**SECTION 4.55(1A) MODIFICATION APPLICATION – MINOR DESIGN MODIFICATIONS
Wilson Park, Sydney Olympic Park**

This application has been prepared by Ethos Urban on behalf of Cricket NSW pursuant to section 4.55(1A) of the *Environmental Planning and Assessment Act 1979* (EP&A Act) to modify Development Consent SSD-10354 relating to Wilson Park, Sydney Olympic Park (the site).

Figure 4 Proposed demolition and tree removal

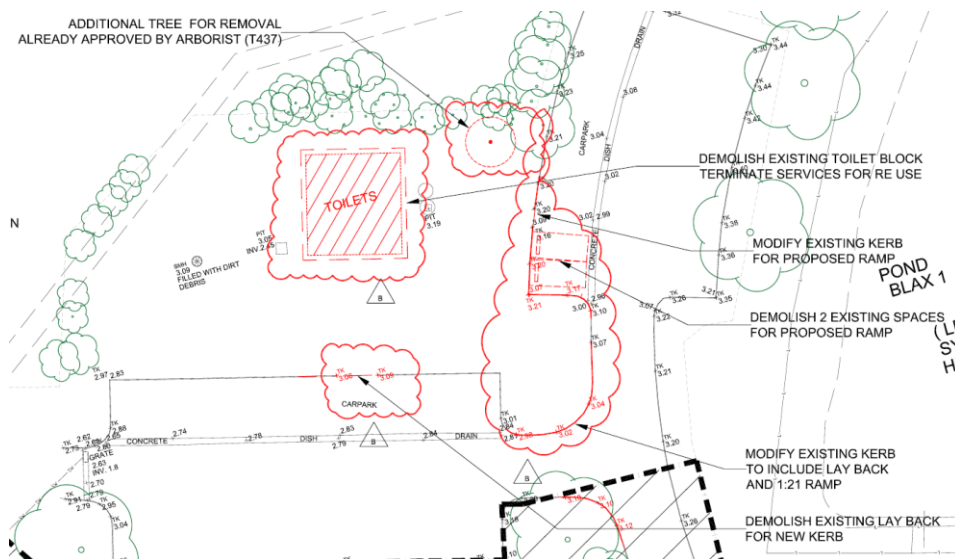
The proposed modifications include minor demolition works including the demolition of the existing toilet block. It also includes demolition of the existing layback and removal of two car spaces to accommodate for the addition of a new kerb. It also proposes to remove one of the existing trees, which was approved for removal by the arborist as part of the original Arboricultural Impact Assessment prepared by New Leaf Arboriculture. The proposed demolition, removal of two car spaces and tree removal are shown in **Figure 4**.

Figure 6 Proposed modified west elevation

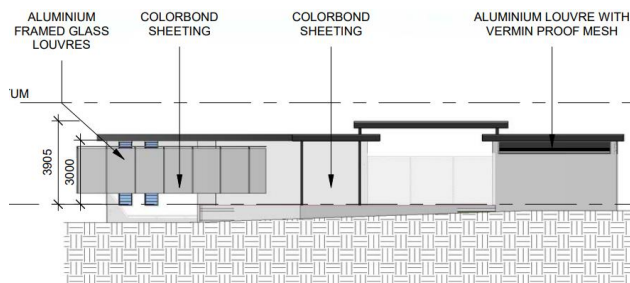
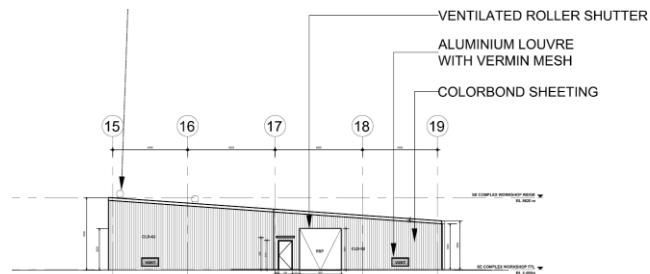
The proposed modification includes a change to the overall design and appearance of the maintenance building, while retaining the existing building footprint. The alteration to the building design involves a minor increase of 0.67m to the building height from RL 7.950 to RL 8.620. This involves a 200mm increase in the slab level to accommodate services and the beam design, while the actual building height has only increased by 0.47m from 4.75m to 5.22m.

The external design generally contains the same materiality apart from the omission of the wire fence and gate, and the addition of polycarbonate roof skylights, however it has changed in configuration, as illustrated in the comparison images of the approved and proposed modified maintenance building at **Figures 5 – 10**.

Figure 11 Proposed location of the washdown bay to the north east of the maintenance building

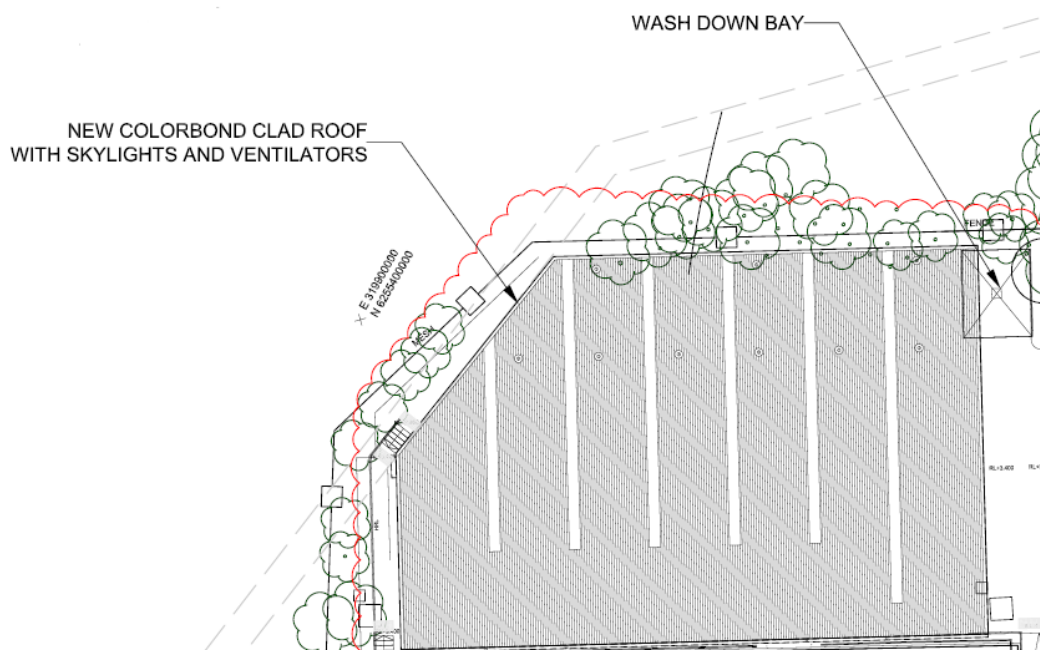
Additionally, a washdown bay is proposed to be included to the north east of the maintenance building, as shown in **Figure 11**. The washdown bay will allow for the cleaning of lawnmowers and other maintenance equipment as required. It has been conveniently located adjacent to the maintenance building's roller shutter doors to allow for easy access to clean maintenance equipment.

Figure 13 Proposed modified general arrangement plan

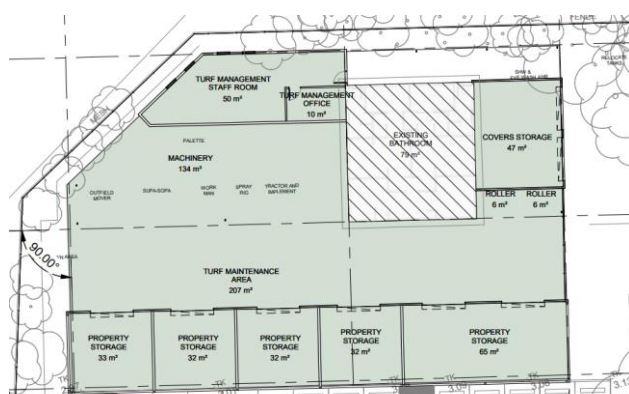
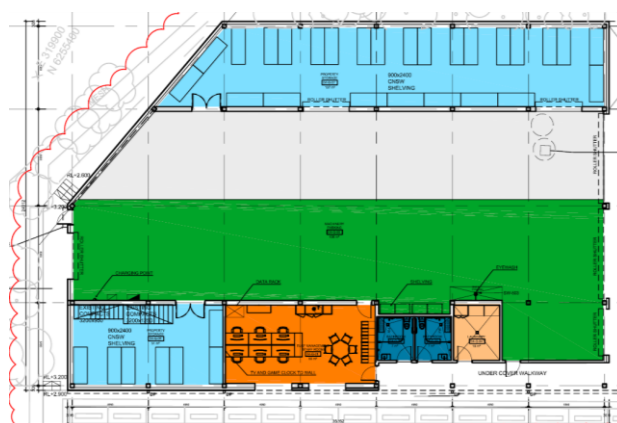
- demolition of the existing toilet block which occupies substantial space, and construction of DDA compliant amenities to the south of the building, allowing for a more efficient internal fit out;
- relocation of most storage from the south of the building to the north, with some storage retained in the south western corner of the building;
- relocation of the management office to the southern portion of the building;
- inclusion of a laundry at the southern part of the building envelope, to the east of the bathroom;

The proposed modifications to the internal layout of the maintenance building are illustrated in **Figure 12** and **Figure 13** below.

Figure 14 Proposed modified kerb and new ramp

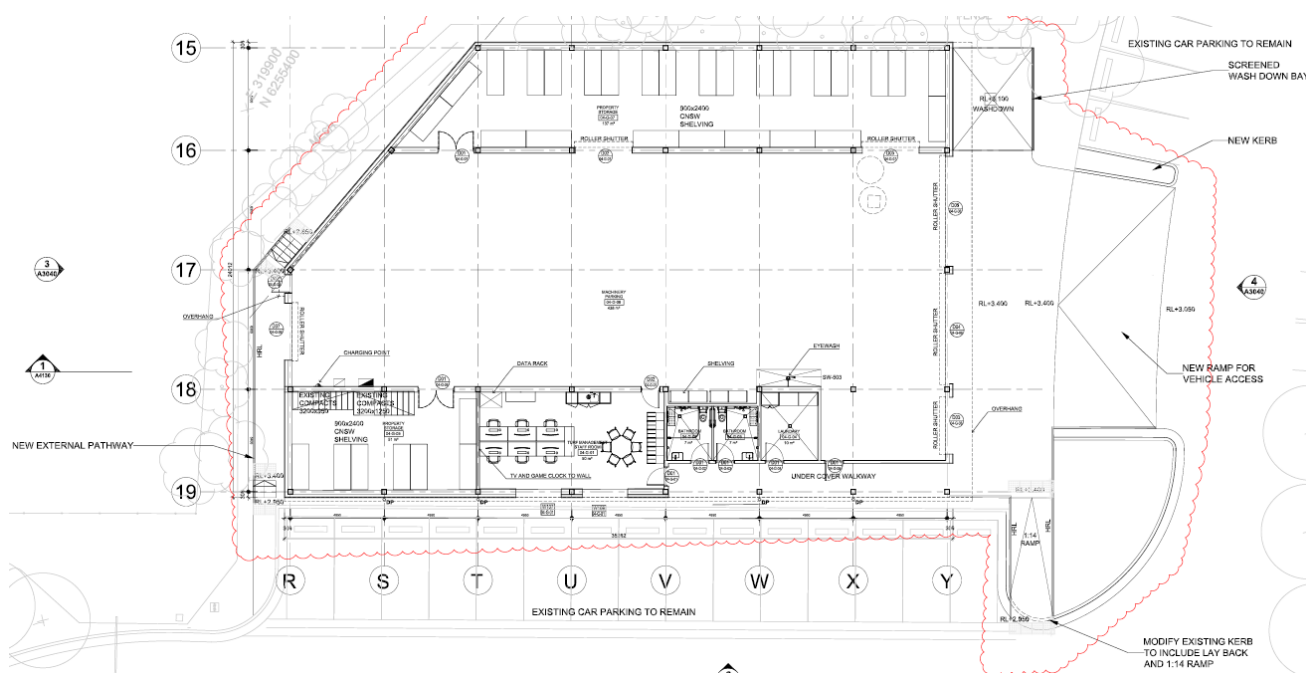
The proposed modifications include removal of two car spaces and alterations to the existing kerb to allow for the accommodation of a new ramp that will provide easier access for maintenance equipment to enter and exit the maintenance building. A 1:14 ramp and handrail has also been included for pedestrian access to and from the building. Additional stairs are also included to the west of the building to account for the slight level change of 200mm. All these changes are illustrated in **Figure 14** below.
